Quality Control Check Report. Stage: After Finishing Stage II (Apartments)

Flat No	C-404	Other	Sl. No.	38484
Company	MPL	Project	Phase	-
Prepared by	T. Vinod Kumar	Sign	Date	29-09-21
Project Manager	Subba Reddy	Sign	Date	29-09-21
Previous stage report no.	37764	Report filed and signed by PM	<input checked="" type="checkbox"/> Yes <input type="checkbox"/> No	
Checked By MD on		MD Sign	<input type="checkbox"/> Yes <input type="checkbox"/> No

MAYFLOWER PLATINUM

Details of Additions & Alterations

Description	WORKING DRAWING OF FLAT.NO.C-4	Direction	N	Owners & Developers :	Modi Properties Pvt Ltd.	Date:	18.08.2020	Promoted by	Modi Properties Pvt. Ltd
				Project Name & Phase :	MAYFLOWER PLATINUM	Prepared By :		Approved By :	Soham Modi
						Scale :	N.T.S		Phone:+91-40-66335551

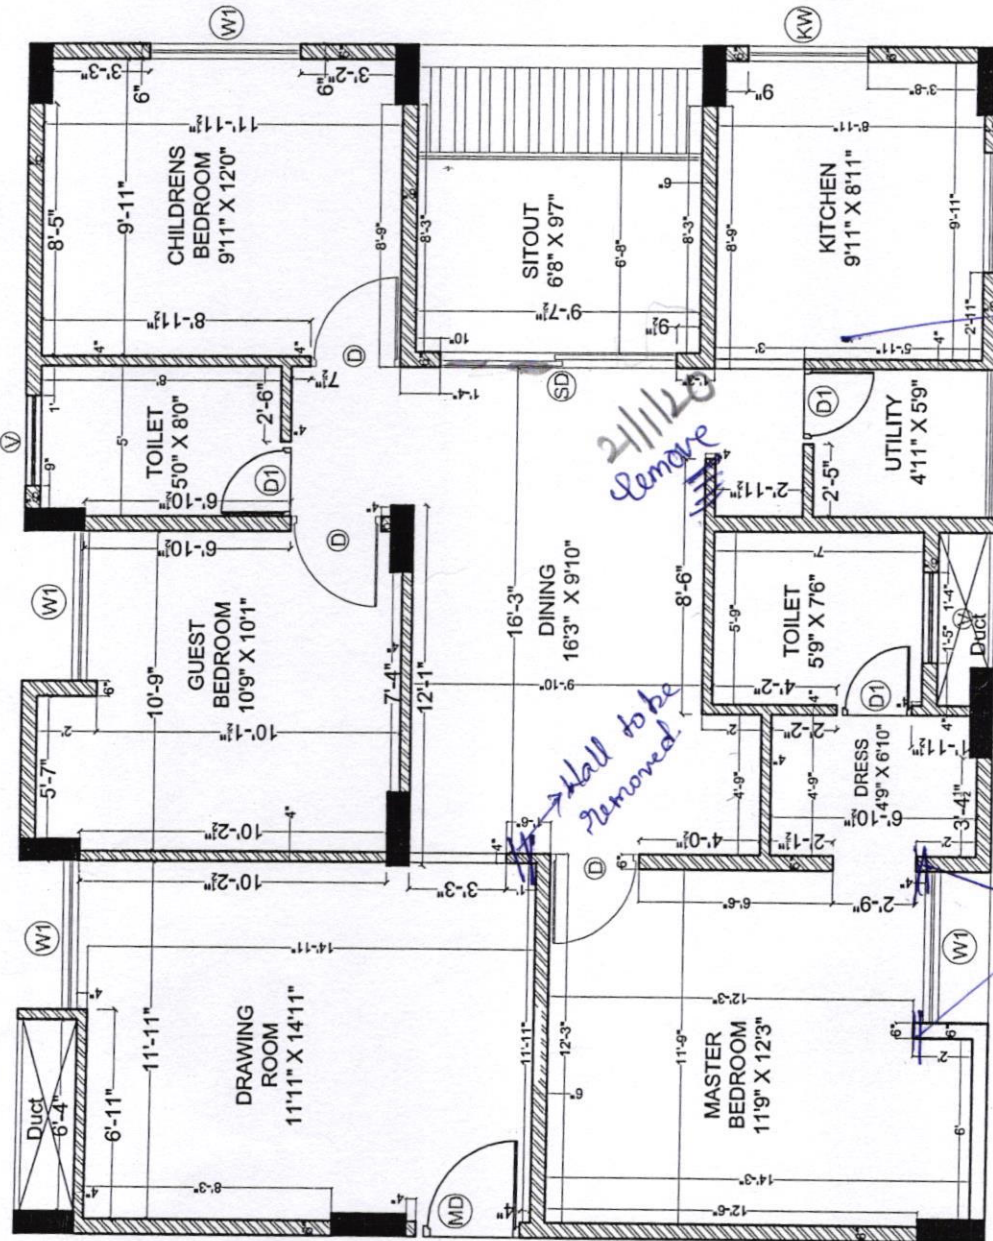
- 1) kitchen platform should be removed
- 2) loft in kitchen to be removed.

- 1) Extra wall to be removed in drawing room marked in plan.
- 2) Wall to be straight to window line in master bedroom marked in plan.
- 3) False ceiling to be done by customer.
- 4) All windows to be 3 track windows including kitchen.

Hall to be removed

To be straight along with window line

left to be removed

Description	ELECTRICAL PLAN OF FLAT-C4		
	Direction	Owners & Developers :	Date :
	N	BNC Estates	18.08.2020
	Project Name & Phase :	Prepared By :	Promoted by
Mayflower Grande	Mayflower Grande	Soham Modi	Modi Properties & Investments Pvt. Ltd.
		Scale :	Phone: +91-40-66335551
		N.T.S

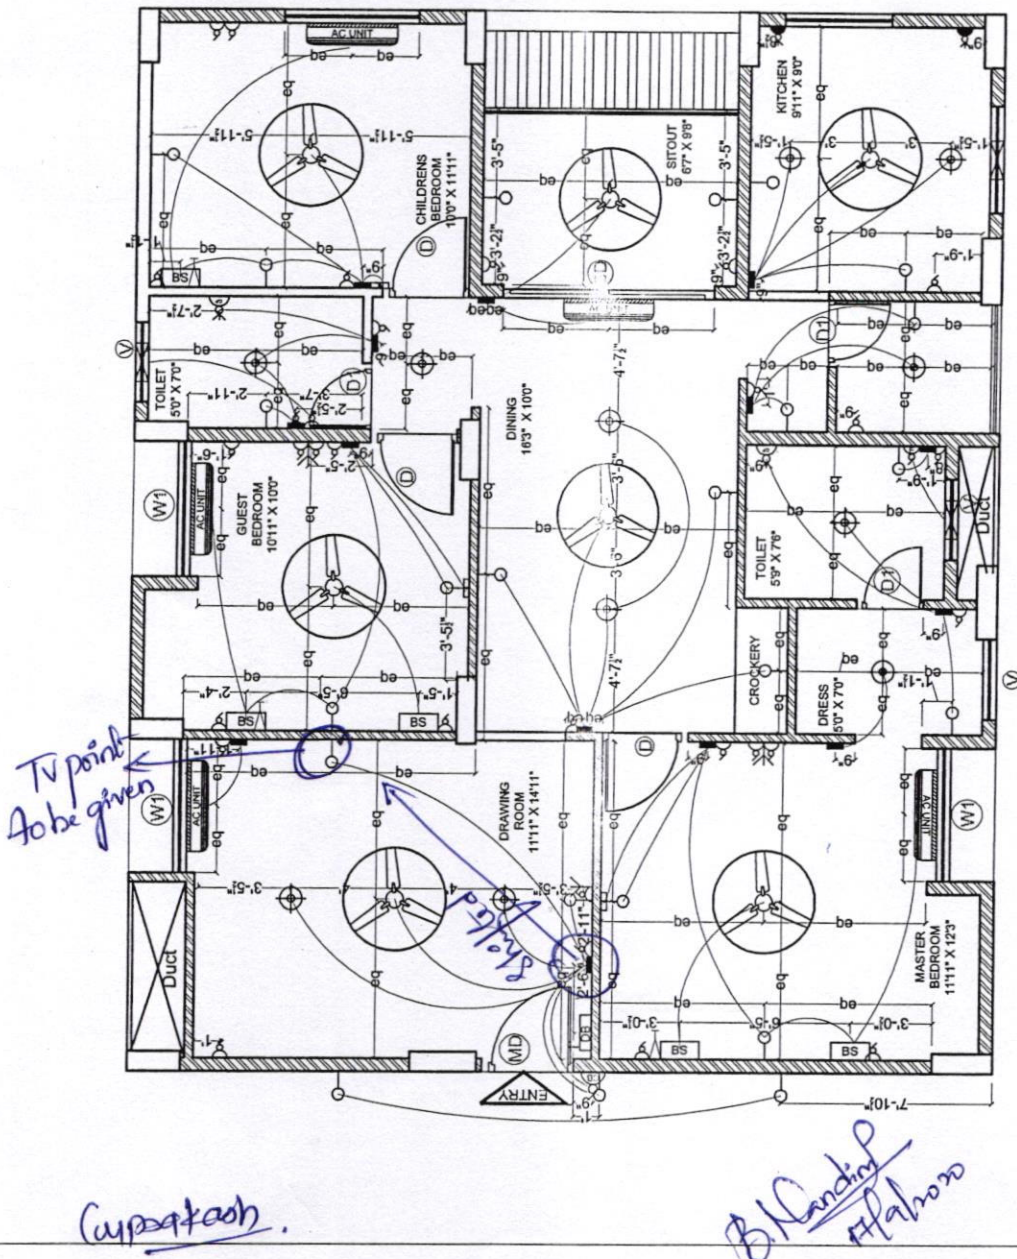
- 1) TV point to be given on guest bedroom wall opposite to main door marked on plan.

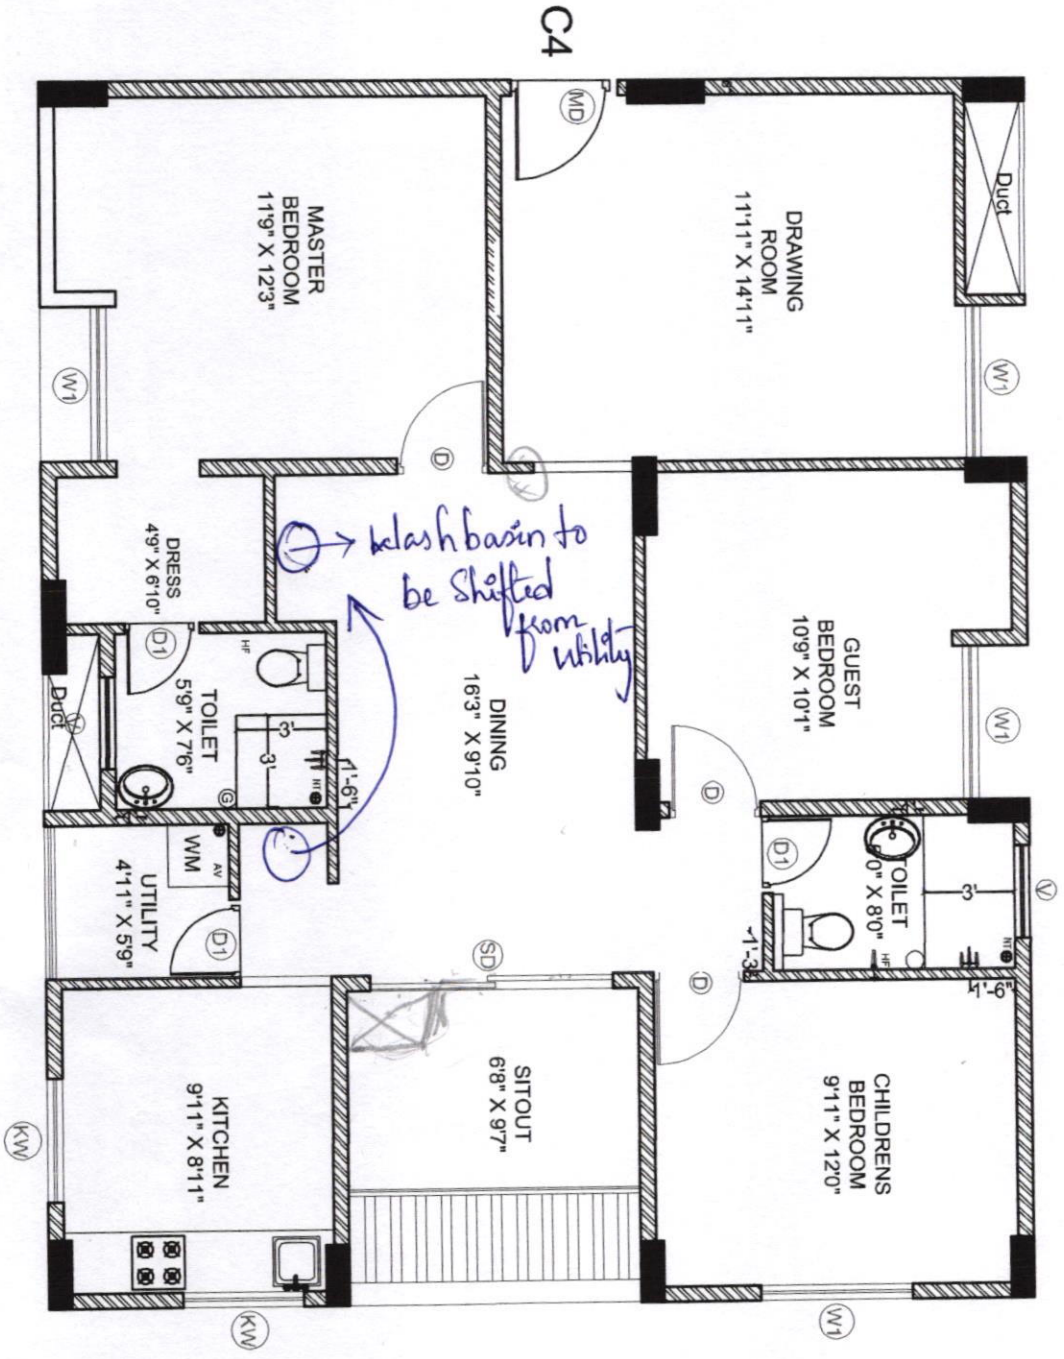
- 1) Master bedroom toilet tiles should be same as common toilet to be brought by customer
- 2) CP fittings & Sanitary will be brought by customer.
- 3) Wash basin point to be shifted from utility area to dining room.
- 4) Two bathroom diverter to be fixed instead of wall mixture - Customer will be bring the diverter fittings.
